# Trunnion Block Check Left Out

**OOFS!** The new edition of the M2 machine gun's TM 9-1005-213-23&P (Mar 02) left out the direct support check and repair for the trunnion block hole. That could cause M2s to be coded out that are still serviceable, which would cost units money.

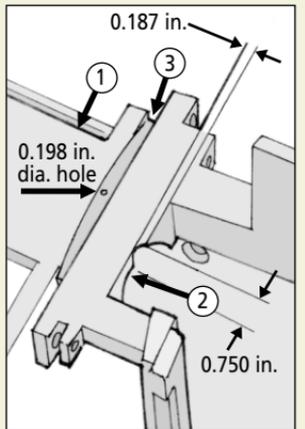
If you have the old TM, the procedure is on Page 3-68. If you don't, here are the two steps:

The check should be on Page 0034 00-3.

Armorer's, make sure your support knows this check is missing. It will be added in the next change to the TM.

**3. Receiver assembly with cracked trunnion block (1) or ragged edges on the rear thin portion of the barrel hole (2) may be repaired by grinding a 0.75-in (1.905-cm) radius, not to exceed a maximum depth of 0.187 inch (0.475 centimeter), as shown.**

**4. Receiver assembly with a hole broken through the feedway of trunnion block stripper slot (3) may be repaired by drilling a .198 to .203-in (.503 to .516-cm) diameter hole, centered in slot (3) to include damaged area.**
